Access Compliance Report

Public Rights-of-Way

Intersection ID: 17733	Main Street: MANOR_RD	Cross Street: TRANQUIL_AV	Location: SE
ADA ID: 56B2F0619051	Ramp Type: PerpDiag	Initial Pass/Fail: Fail	Overall Compliance: No
		Severity Score: 37.5

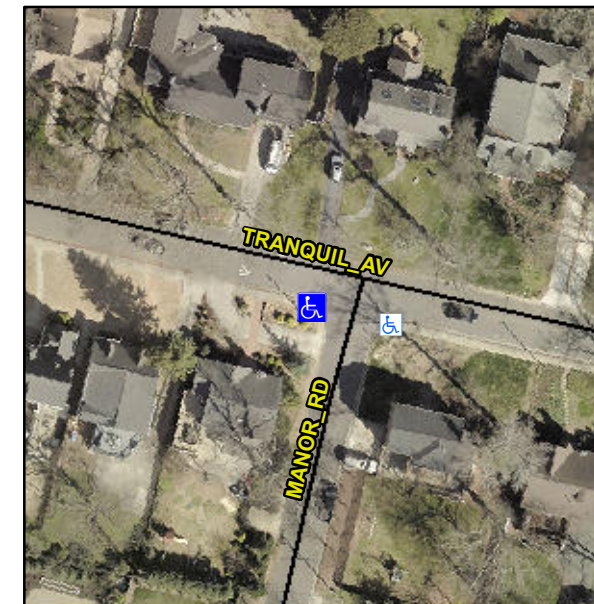
Not Found, R304.2.2, R304.5.3

Compliance	Description	Data	Compliance	Description	Data
N/A	Ramp Length (in)	47.0	No	Ramp Slope (%)	11.5
Yes	Ramp Width (in)	51.0	No	Ramp XSlope (%)	11.1
N/A	Flare Type LT	N/A	N/A	Flare Type RT	N/A
N/A	Flare Slope LT (%)	N/A	N/A	Flare Slope RT (%)	N/A
N/A	Flare Traversable LT?	N/A	N/A	Flare Traversable RT?	N/A
N/A	Landing Length (in)	N/A	N/A	DWS Provided?	N/A
N/A	Landing Width (in)	N/A	N/A	DWS Contrast?	N/A
N/A	Landing Slope (%)	N/A	N/A	DWS Length (in)	N/A
N/A	Landing X Slope (%)	N/A	N/A	DWS Full Width?	N/A
N/A	Landing Curb? (Y/N)	N/A	N/A	DWS Offset (in)	N/A
N/A	Shared Landing?	N/A			
N/A	Gutter Ponding?	N/A	N/A	Gutter Slope (%)	N/A
N/A	Gutter Lip Ht (in)	N/A	N/A	Gutter X Slope (%)	N/A
N/A	Painted X Walk1?	No	N/A	Painted X Walk2?	No
	X Walk 1 Direction	To SE		X Walk 2 Direction	To NE
N/A	X Walk 1 Width (in)	N/A	N/A	X Walk 2 Width (in)	N/A
	X Walk 1 Slope (%)	3.7		X Walk 2 Slope (%)	9.9
	X Walk 1 X Slope (%)	16.9		X Walk 2 X Slope (%)	1.2

Remove & Replace Curb Ramp With Two New Directional Ramps or Equivalent.
